Certificate of Appropriateness Case Report

Filing Date: April 10, 2013
Case No.: **2012.0799A**
Project Address: **270 BRANNAN STREET**
Historic Landmark: South End Landmark District
Zoning: MUO (Mixed-Use Office) Zoning District
65-X Height and Bulk District
Block/Lot: 3774/026
Applicant: Steve Shanks, SKS Investments, Inc.
601 California Street, Ste. 1310
San Francisco, CA 94108
Staff Contact: Richard Sucre - (415) 575-9108
richard.sucre@sfgov.org
Reviewed By: Timothy Frye - (415) 575-6822
tim.frye@sfgov.org

DATE: June 27, 2013
TO: Steve Shanks, SKS Investments
FROM: Rich Sucre, Historic Preservation Technical Specialist,
(415) 575-9108
REVIEWED BY: Architectural Review Committee of the Historic Preservation
Commission
RE: **Meeting Notes - Review and Comment at the June 19, 2013 ARC-HPC
Hearing for 270 Brannan Street, Case No. 2012.0799ABX**

BRANNAN STREET ELEVATION
1" = 20'-0" **1**

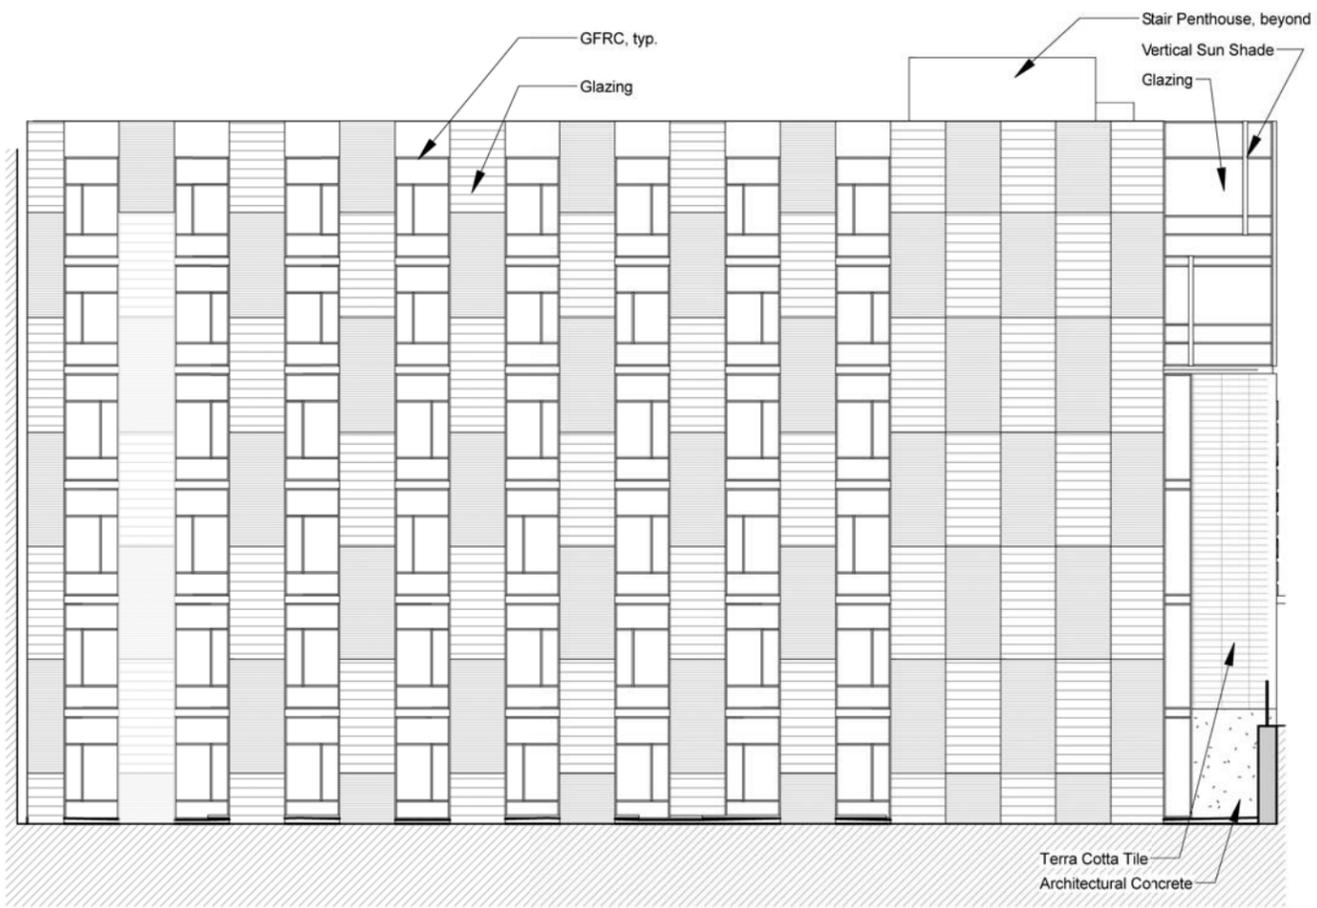
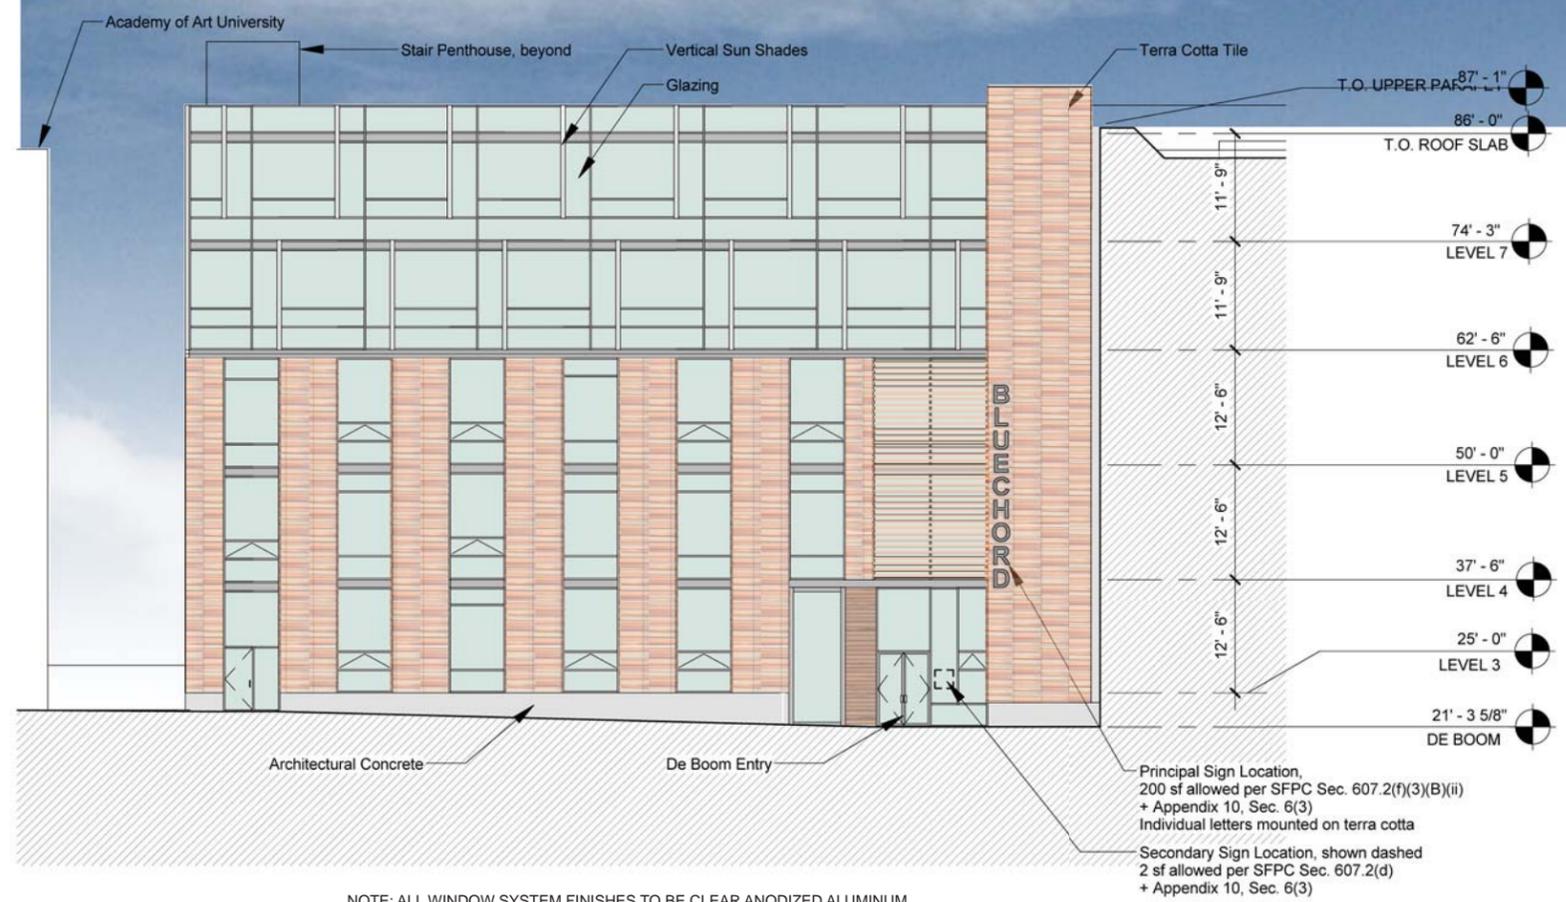
The ARC recommends refinement of the main entryway on Brannan Street to better emphasize the entrance and/or provide for more regularity above or a more vertical element above the main entryway.

ARC Comment	Design Team Response
<p>Compatibility of New Construction with Landmark District: Overall, the ARC concurs with the staff determination that the new construction appears generally compatible with the surrounding landmark district and its character-defining features. In particular, the ARC found the massing, form and materials to be appropriate and compatible with the surrounding landmark district. In particular, the ARC commented on the success and design of the De Boom street façade, as related to the surrounding district.</p>	<p>Thank you for the positive feedback.</p>
<p>Brannan Street Entrance: The ARC recommends refinement of the main entryway on Brannan Street to better emphasize the entrance and/or provide for more regularity above or a more vertical element above the main entryway.</p>	<p>Brannan Street façade revised to reinforce the main entry, in particular with a recess in the façade and increased glass area. The result is a more regular bay spacing and enhanced inflection at the entry.</p>
